FILE # # G-17590

PUBLIC INTEREST REVIEW FOR GROUND WATER APPLICATIONS

SUBJECT: Application G- 17590 Supersedes review of _____
Date of Review(s) _____

A. GENERAL INFORMATION: Applicant's Name: David Sheets County: Jefferson

G-17590: Brewer Reservoir and Grizzly Mtn Quadrangles

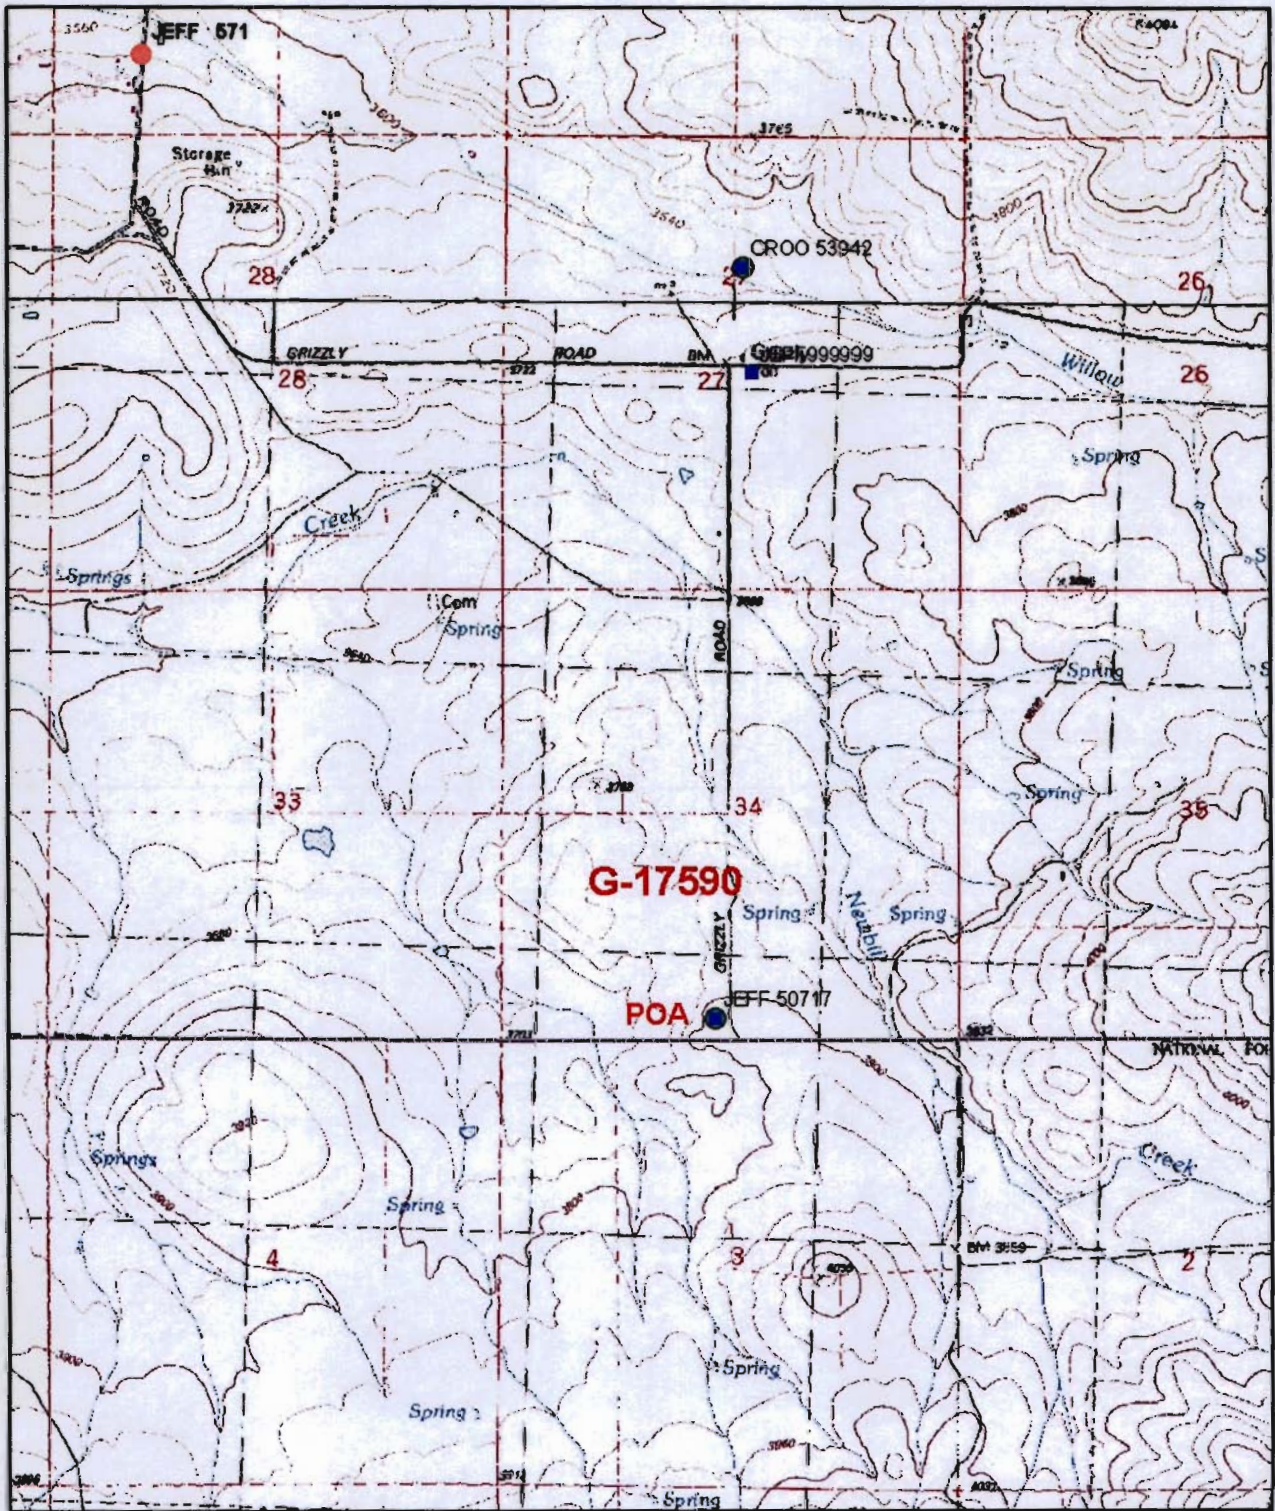
NO NEARBY STATE OBSERVATION WELL IS COMPLETED IN THE CLARNO FM. HOWEVER, THE WATER LEVEL TREND IN A STATE OBSERVATION WELL NEAR MADRAS (OBS WELL 1306 (JEFF 466)), LOCATED ABOUT 12.5 MILES TO THE NORTHWEST IS LIKELY SIMILAR. ALTHOUGH THAT WELL IS COMPLETED IN THE DESCHUTES FM. THE WELL HAS BEEN MONITORED PERIODICALLY SINCE THE MID-1980s. THE GROUND WATER LEVEL HAS SEASONALLY FLUCTUATED ABOUT 1 TO 7 FEET DURING THE PERIOD OF RECORD. CLIMATE INFLUENCE IS APPARENT AT STATE OBS WELL 1306.
